Second Millport Coastal Flood Protection Scheme, Community Consultation Questionnaire

Summary of Results

Client: North Ayrshire Council

Reference: WATPB4749R011D0.3

Option 1 – Millport Pier Extension

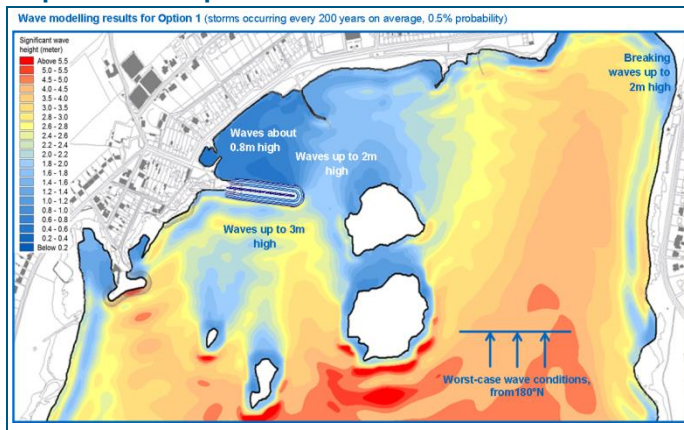
Strong opinion was voiced (50 comments) about the potential negative impact of extending the pier (Option 1). Comments expressed a strong desire to maintain the function currently provided by the timber part of the pier. Issues raised about the proposed rock armour extension included visual impact, navigation constraints and harbour access, potential risk of sediment loss from Newtown beach, impact on natural environment.

Four respondents preferred this option over the offshore breakwaters, and 9 comments recognised that this option could potentially be acceptable if there was berthing for boats on the inshore side of the breakwater.

Option 2 – Offshore breakwater with navigation channel

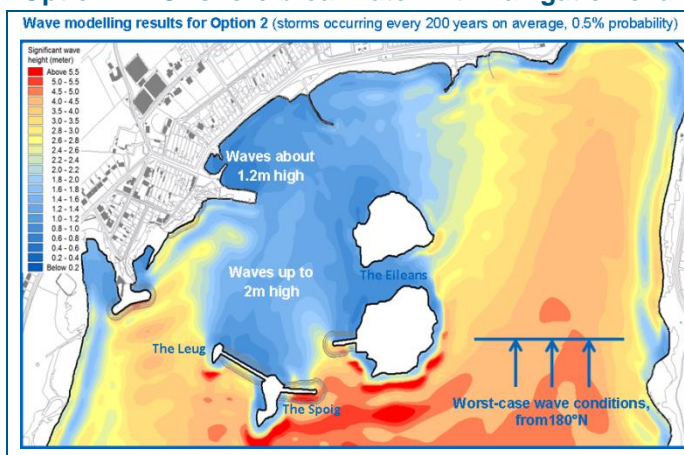
Comments preferring Option 2 (offshore breakwaters with navigation channel) mainly referred to a preference to maintain the existing navigation channel. Comments preferring Option 3 (continuous breakwater) recognised the increased shelter provided for vessels. However, negative comments on Option 3 highlighted the impacts on navigation, particularly for larger vessels (16 comments).

A few comments were made about the visual impact of offshore breakwaters, with more negative comments about Option 3 (6 comments) than Option 2 (3 comments).

Option 3 – Continuous offshore breakwater

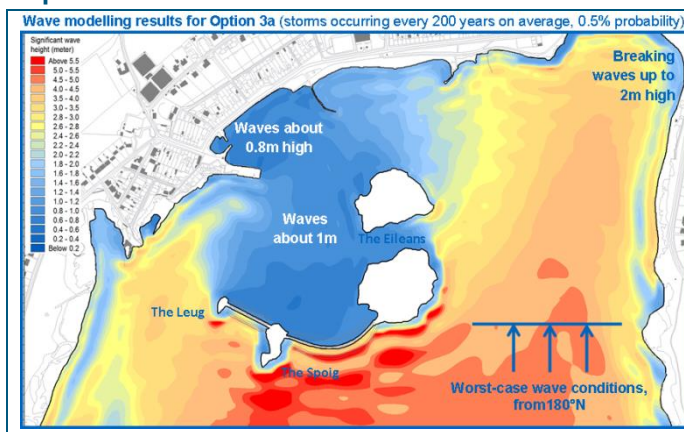
For all of the Stuart Street options there were comments made about whether the extent of the proposed works was necessary in relation to the level of flood risk. This issue was raised most often in relation to Option 3 (6 comments).
